Meeting Minutes – 12/17/14

Revised Cooling Sections

Matching Solenoid w/corrector

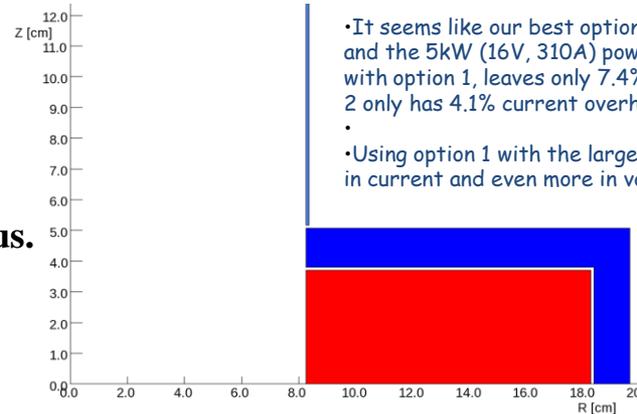
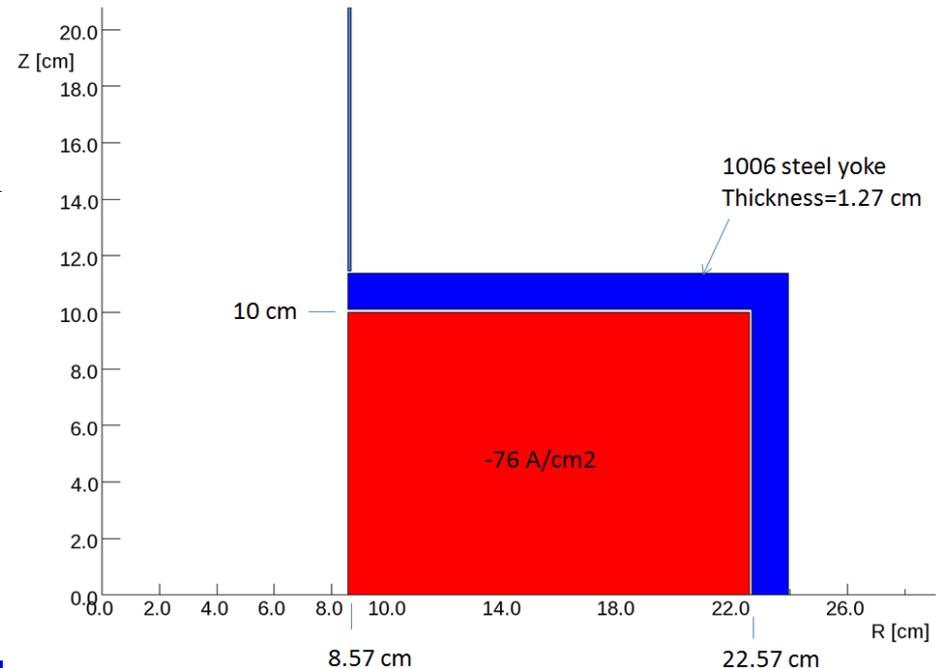
- 4 required in cooling section w/o bucking coil
- Corrector 100 Gcm, present specification.
- **Layout coil winding**
- **Can solenoid be longer or wider? w/o water cooled bus.**

- It seems like our best option here is to go with option 1 and the 5kW (16V, 310A) power supply. The smaller supply with option 1, leaves only 7.4% current overhead, but option 2 only has 4.1% current overhead.
-
- Using option 1 with the larger supply means we'll have 24% in current and even more in voltage.

180° Dipole Magnet

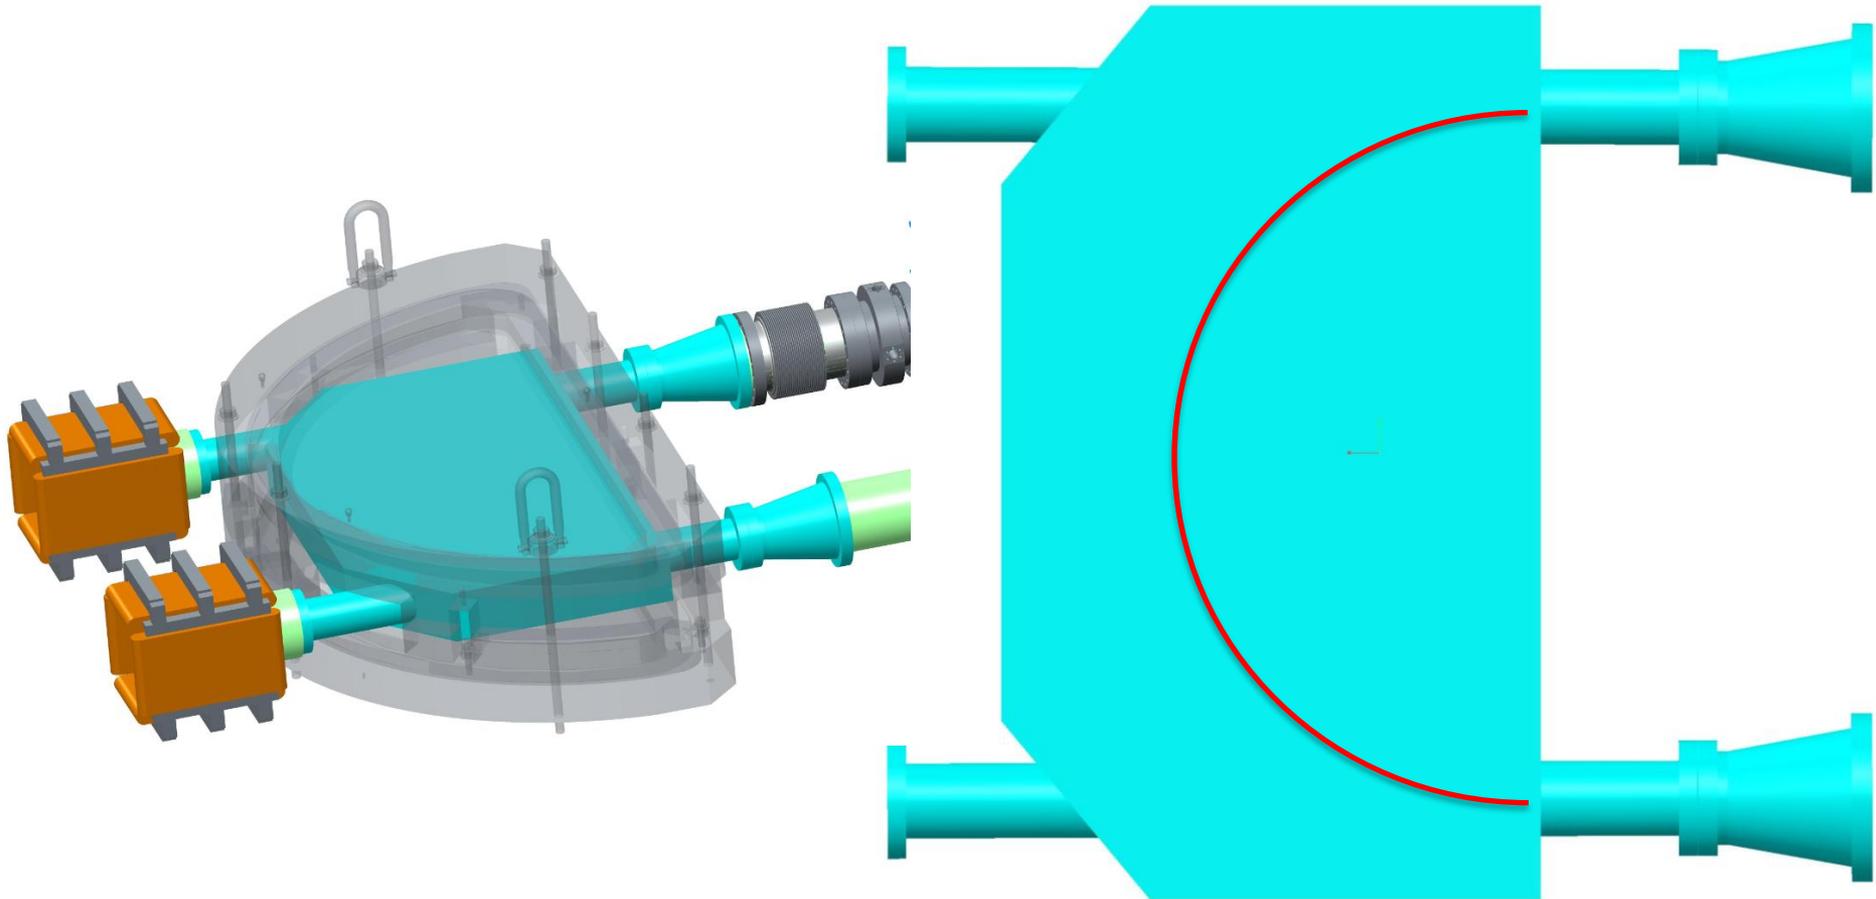
Large open 180° vacuum chamber: are there beam impedance concerns? Should the electron beam path be shielded?

Similar issue for 21° chamber?

Beam Dump Line to Vacuum Valve:

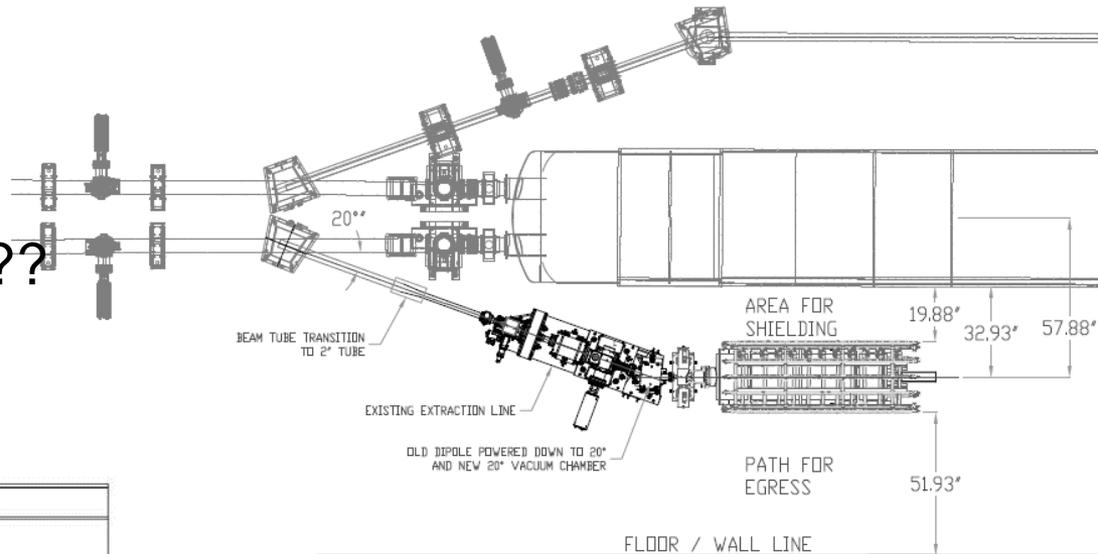
- (4) 20o dipoles 10 cm aperture
- Or
- (2) 20o dipoles 10 cm aperture
- (2) 20o dipoles 6 cm aperture ??

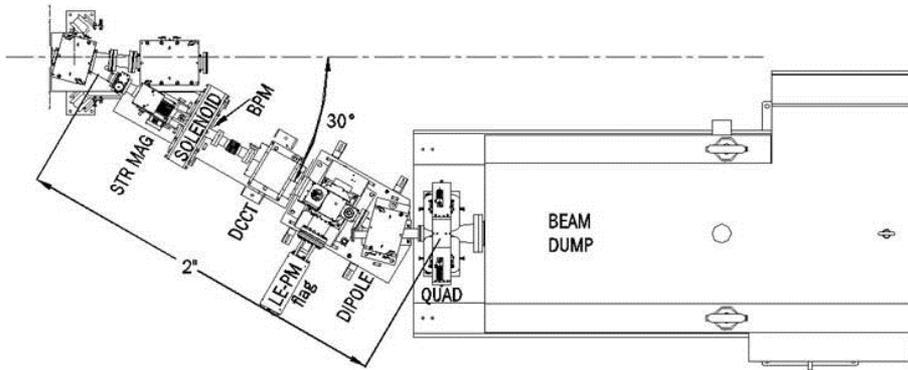
What components can we take from ERL extraction line? To be determined.

TITLE: HEADER

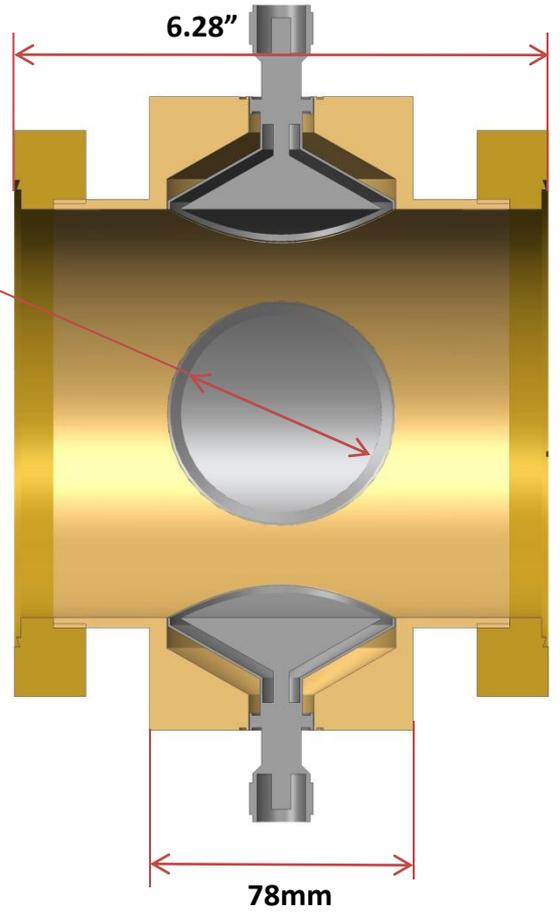
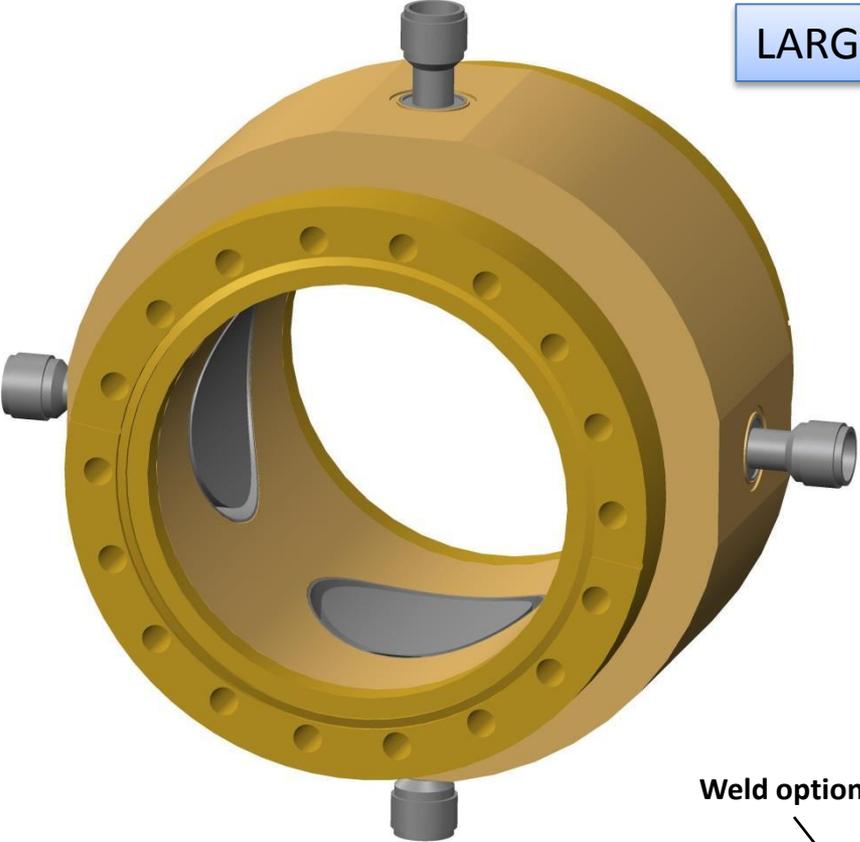
- Phone conference with MPF
- Larger diameter buttons on pick-up – 27 to 30 mm diameter
- Machined vacuum chamber, 304L, no threaded holes on flanges.
- Button hole size TBD microwave studio (D. Gassner).
